FINAL PLAT OF
"ROONEYS' FIRST ADDITION"
SEDGWICK COUNTY, KANSAS
IN THE NE 1/4 OF SECTION 17, T29S, R1W OF THE 6TH P.M.

RE: S/D 00-18 -- One-Step Final Plat of ROONEYS' FIRST ADDITION

RE: S/D 00-18 -- One-Step Final Plat of ROONEYS' FIRST ADDITION

CASE NUMBER: S/D 00-18 -- ROONEYS' FIRST ADDITION

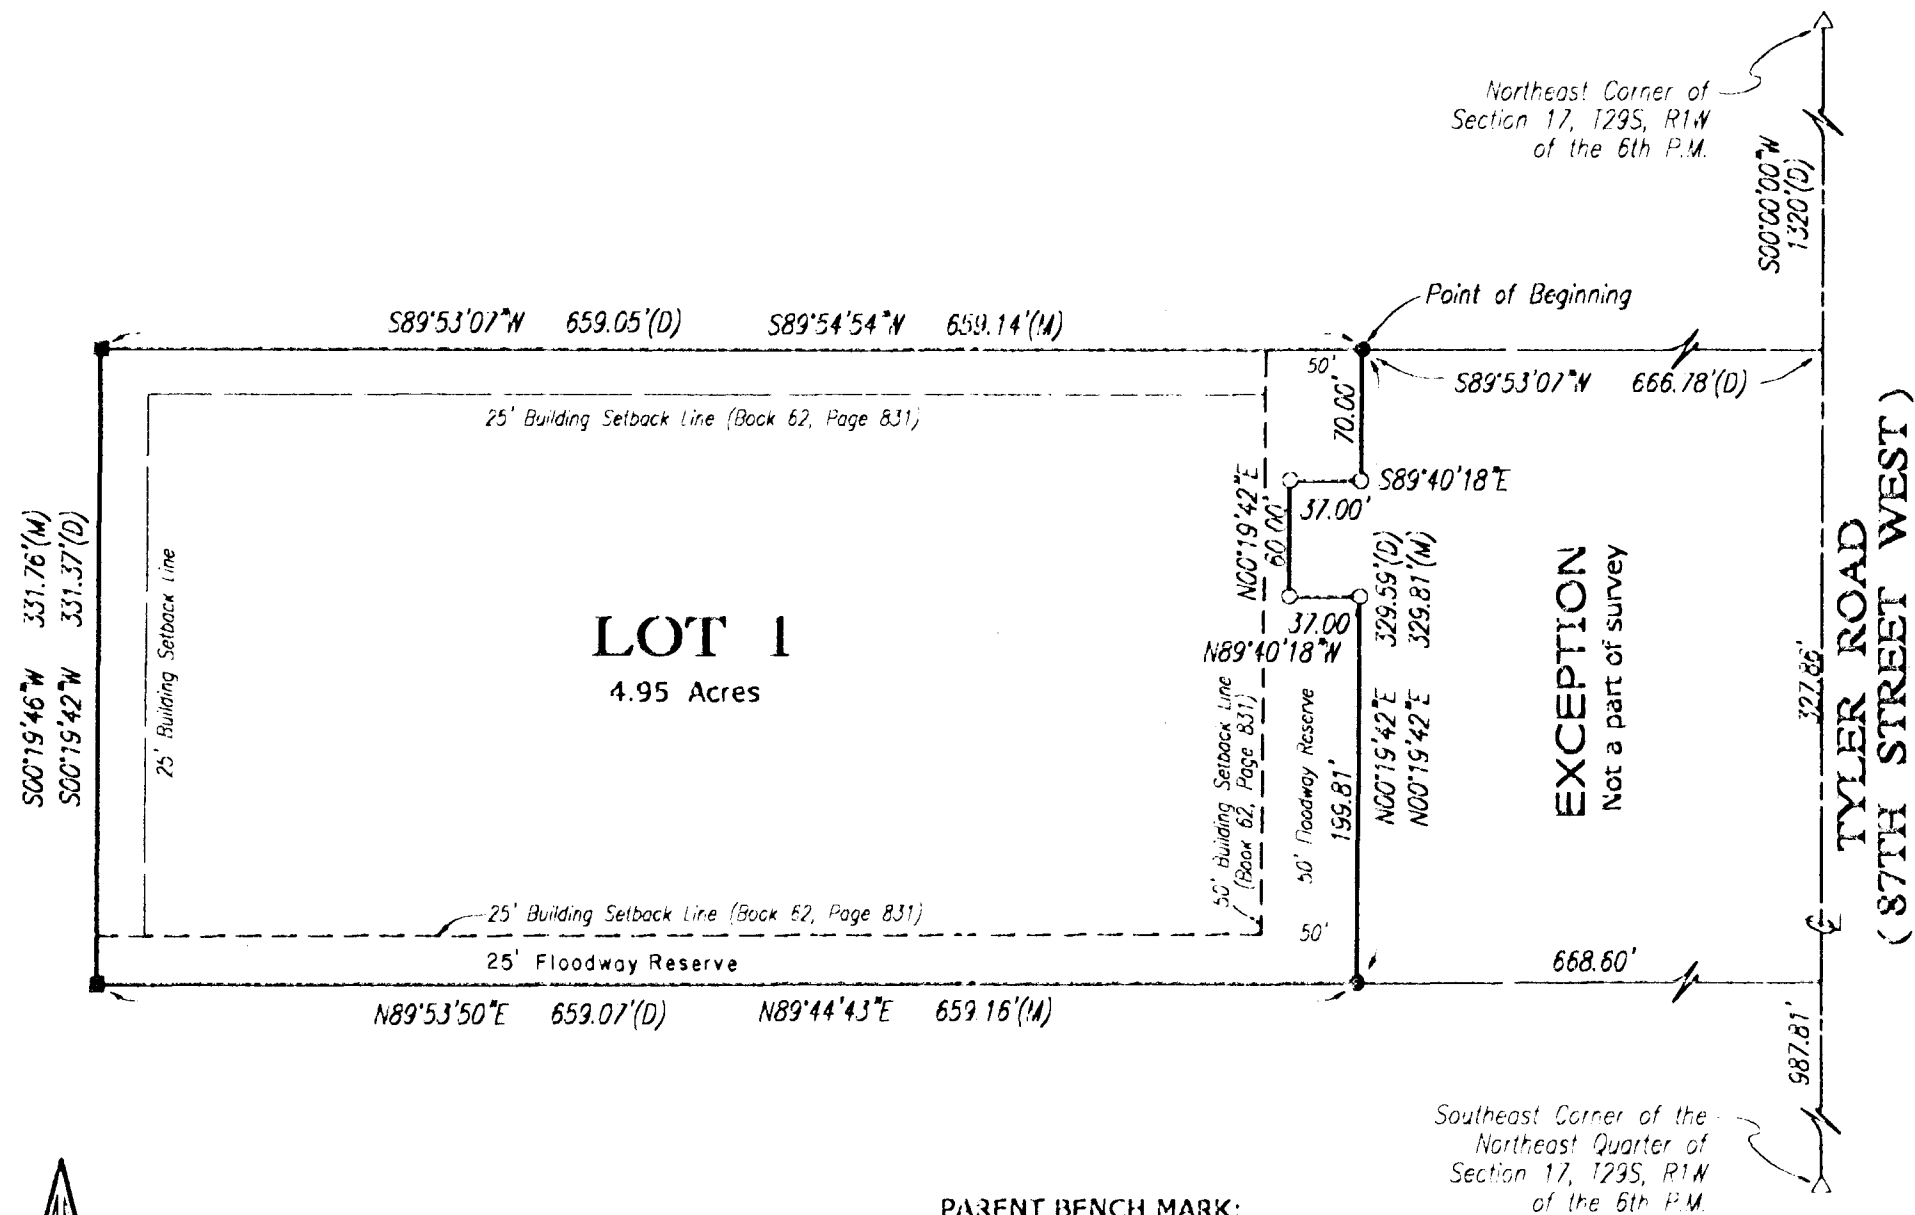
- C. **County Engineering** needs to comment on the status of the applicant's drainage plan. **The drainage plan is approved. A Floodway Reserve is required along the south lot line and on the east lot line.**

- D. **County Engineering** and **County Fire Department** needs to comment on the access to this property. The plat proposes access through an existing 50-ft private street which currently serves three lots. The Subdivision regulations limit private streets to serving no more than three lots. Approval of the proposed plat would require a modification from the Subdivision regulations. An ingress/egress easement needs to be established by separate instrument which includes this lot. **County Fire Department has approved the site for a 24' wide access road. The Subdivision Committee have the approved the access road for four total lots.**

- E. The platlor's text shall note the creation of the floodway reserve in addition to referencing the standard floodway language.
- F. For those reserves being platted for floodway purposes, the required covenant which provides for ownership and maintenance of the reserves shall grant, to the appropriate governing body, the authority to maintain the reserves in the event the owner fails to do so. The covenant shall provide for the cost of such maintenance to be charged back to the owner by the governing body.

- H. The platlor's text shall include language that a drainage plan has been developed for the plat and that all drainage easements, rights-of-way, or reserves shall remain at established grades or as modified with the approval of the applicable City or County Engineer, and unobstructed to allow for the conveyance of stormwater.
